RE: PLUS review – 2008-07-05; Georgetown Commons

Thank you for meeting with State agency planners on July 23, 2008 to discuss the proposed plans for the Georgetown Commons project to be located at 301 S. DuPont Blvd. within the Town of Georgetown.

According to the information received, you are seeking a rezoning and site plan approval through the Town of Georgetown for a 200,000 sq. ft. industrial building.

# **Map of Georgetown Commons (PLUS 2008-07-05)**

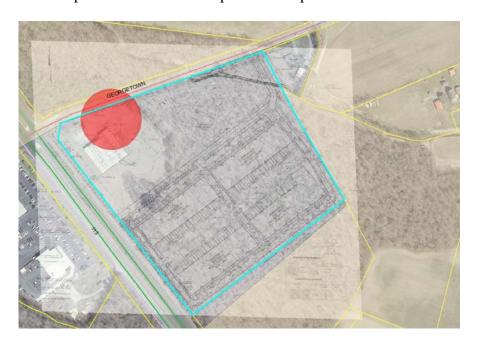
The applicant estimates this project's post-construction surface imperviousness to reach about 60-65 percent. However, given the scope and density of this project (i.e., as viewed from the conceptual project layout) this estimate is likely a significant underestimate. When calculating surface imperviousness, it is important to include all forms of constructed surface imperviousness (i.e., rooftops, sidewalks, open-water stormwater management structures/ponds, and roads) in the calculation for surface imperviousness; this will ensure a realistic assessment of this project's likely post-construction environmental impacts. Consequently, the applicant should recalculate this project's surface imperviousness with all of the above-mentioned forms of surface imperviousness included. Failure to do so will significantly understate this project's true environmental impacts.

This project proposes to clear at least 50-55% of the existing forest. The forested area that remains will be completely fragmented by buildings and infrastructure.

- 2. There should be at least a 100-foot upland buffer between site plan features (including stormwater ponds) and wetland boundaries. The current site plan only has the minimum buffer required. Current County requirements do not appear to recognize ecological needs, which are supported by scientific research. Upland buffers not only protect the function and integrity of wetlands, but also provide critical breeding habitat for wetland dependent species during a portion of their life cycle.
